**1<sup>st</sup> Further Information**

**Temporary Holiday Camp, Place of Recreation, Sports or Culture, Barbecue Site  
and Eating Place with Ancillary Facilities and Associated Filling of Land and Pond  
for a Period of 3 Years in "Agriculture" Zone,  
Various Lots in D.D. 107 and D.D. 109, Fung Kat Heung, Kam Tin, Yuen Long, New Territories**

**(S.16 Planning Application No. A/YL-KTN/1253)**

**Appendix V - Response-to-Comments Table**

FILLING OF LAND AND POND

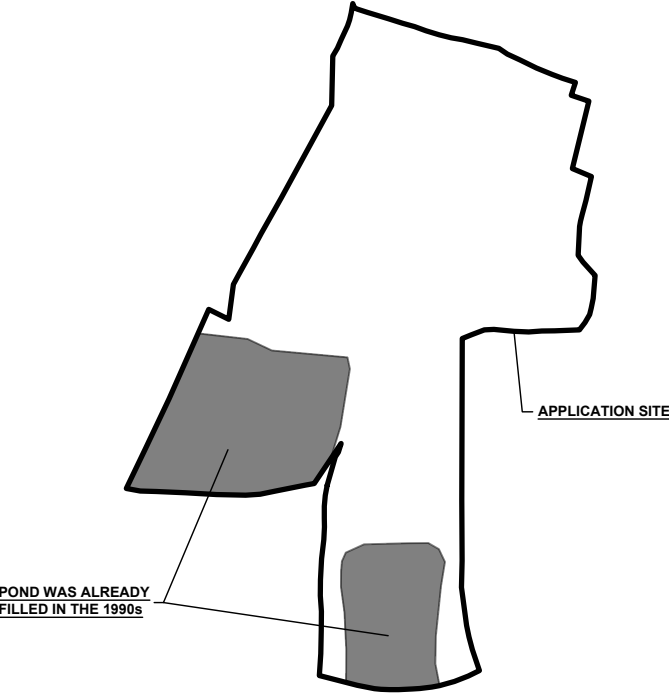
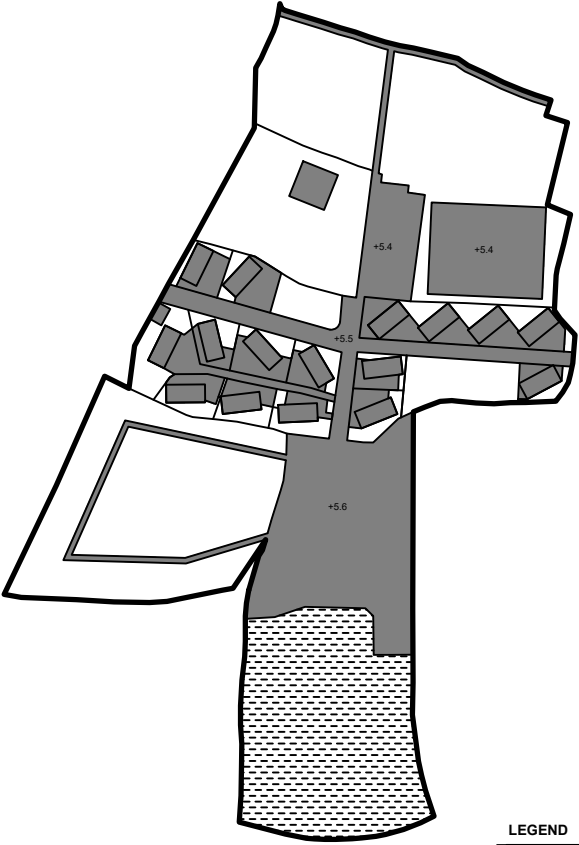
| <b>Comments of the Chief Engineer/Mainland North, Drainage Services Department (CE/MN, DSD)<br/>(Contact Person: Mr. Fraco TSANG; Tel: 3965 8926)</b> |                                                                                                                                                                                                                                                                                                                                                                                                                                                                                                 |                                                                                                                                                                                                                                                                                                                                        |
|-------------------------------------------------------------------------------------------------------------------------------------------------------|-------------------------------------------------------------------------------------------------------------------------------------------------------------------------------------------------------------------------------------------------------------------------------------------------------------------------------------------------------------------------------------------------------------------------------------------------------------------------------------------------|----------------------------------------------------------------------------------------------------------------------------------------------------------------------------------------------------------------------------------------------------------------------------------------------------------------------------------------|
| (1)                                                                                                                                                   | A section which discuss the proposed development should be included. Please confirm if there is no land filling works / change of ground level. The changes in paving conditions of sub-catchments and the corresponding induced surface runoff due to the proposed development, which is the drainage impact, i.e. the core of this report, should be clearly shown. It should be noted that Section 5 only demonstrates that the induced drainage impact can be catered by the existing pond. | Noted. Section 2 is revised ( <b>Appendix VI</b> ).                                                                                                                                                                                                                                                                                    |

THE APPLICATION SERVES TO REGULARISE THE FILLED POND WHICH HAS ALREADY BEEN FILLED IN THE 1990s. NO FILLING OF POND WILL BE CARRIED OUT BY THE APPLICANT AFTER OBTAINING PLANNING PERMISSION FROM THE BOARD.

PART THE APPLICATION SITE (5,887 m<sup>2</sup>) HAS ALREADY BEEN HARD-PAVED (4,110 m<sup>2</sup>) AND COVERED BY GRAVEL (1,777 m<sup>2</sup>) RESPECTIVELY. NO FURTHER FILLING OF LAND WILL BE CARRIED OUT AFTER PLANNING PERMISSION HAS BEEN GRANTED FROM THE TOWN PLANNING BOARD.

Response to Comment Table Based on Comments in  
Dec 2025 Report

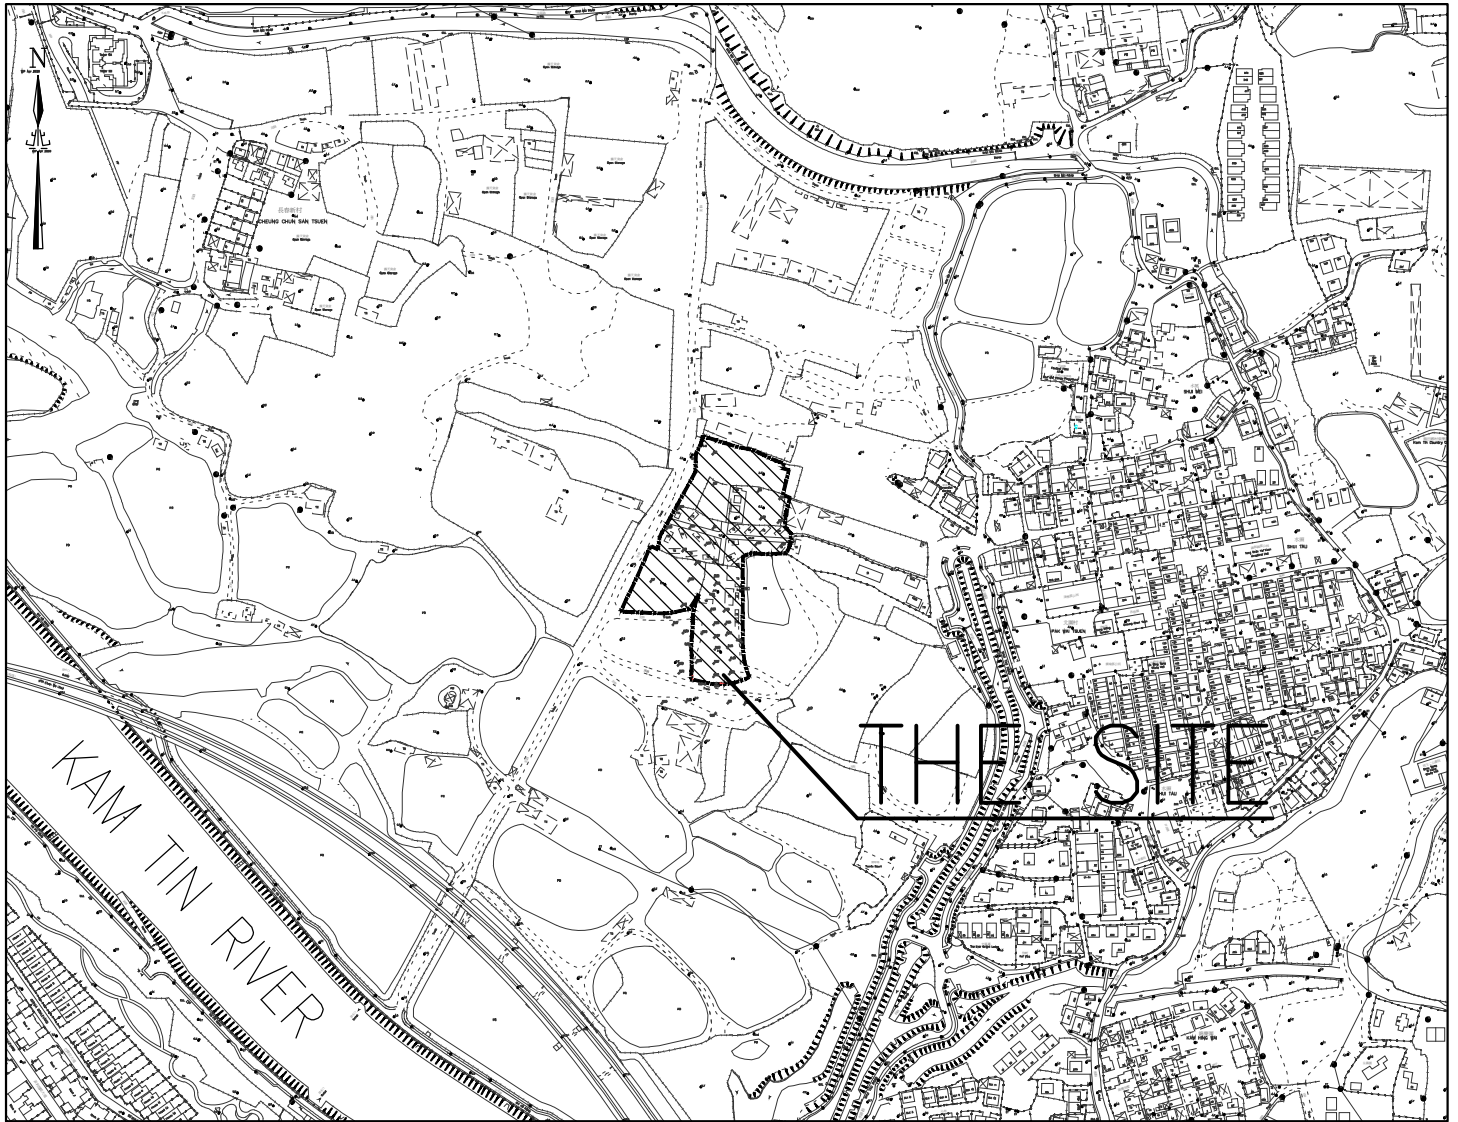
| DSD/LD Comment                                                                                                                                                                                                                                                                                                                                                                                                         | Response to DSD/LD Comments                                                                                                                                                                                                                                                                                |
|------------------------------------------------------------------------------------------------------------------------------------------------------------------------------------------------------------------------------------------------------------------------------------------------------------------------------------------------------------------------------------------------------------------------|------------------------------------------------------------------------------------------------------------------------------------------------------------------------------------------------------------------------------------------------------------------------------------------------------------|
| 1 The applicant should indicate the proposed and existing ground levels of the application site and ground levels of adjacent areas on the drainage plan.                                                                                                                                                                                                                                                              | Noted. The proposed level, existing ground level and ground levels of adjacent areas are shown in the drainage plan.                                                                                                                                                                                       |
| 3 The newly promulgated Stormwater Drainage Manual - Corrigendum shall be considered in the hydraulic calculation. Also, storm constants of Hong Kong Observatory Headquarters instead of North District Area shall be adopted in the hydraulic calculation.                                                                                                                                                           | Noted. The hydraulic calculation has been revised according to the latest Corrigendum. The storm constants use data from the Hong Kong Observatory Headquarters in this submission.                                                                                                                        |
| 5 Drawing (No.: WNG/24168/C/DRA/002) & Appendix B: The applicant should consider catchment area between Catchment 1 and existing pond. Also, the applicant should review catchment area and                                                                                                                                                                                                                            | Noted. The catchment area is revised to include the area between Catchment 1 and existing pond. The runoff coefficient is revised to following: Hard paved area - 0.95,                                                                                                                                    |

| 6 Drawings (No.: WNG/24168/C/DRA/001 & WNG/25086/C/DRA/003) & Appendix B: The applicant should clarify size of the proposed surface channel (Branch 3). Also, the applicant should review invert levels of the proposed drainage facilities. Invert levels of drainage facilities at the upstream should be higher than that at the downstream. | Noted. The drawing is revised accordingly.                                                                                                                                      |
| 7 Drawings (No.: WNG/25086/C/DRA/003 & WNG/24168/C/DRA/004): The applicant should clarify discrepancy of size and location of the proposed drainage facilities. Besides, the proposed surface channel (Branch 1) is missing in Section C-C.                                                                                                     | Noted. The drawing is revised accordingly.                                                                                                                                      |
| 8 Drawing (No.: WNG/25086/C/DRA/003): The applicant should clarify discharge point of the proposed catchpit C.P.E. The applicant should provide details for the connection of the proposed and existing drainage facilities mentioned in the proposal.                                                                                          | Noted. Further to the revised drawing, the discharge point should be catchpit CP5.<br>The detail for the connection of the proposed and existing drainage is shown on Figure 8. |
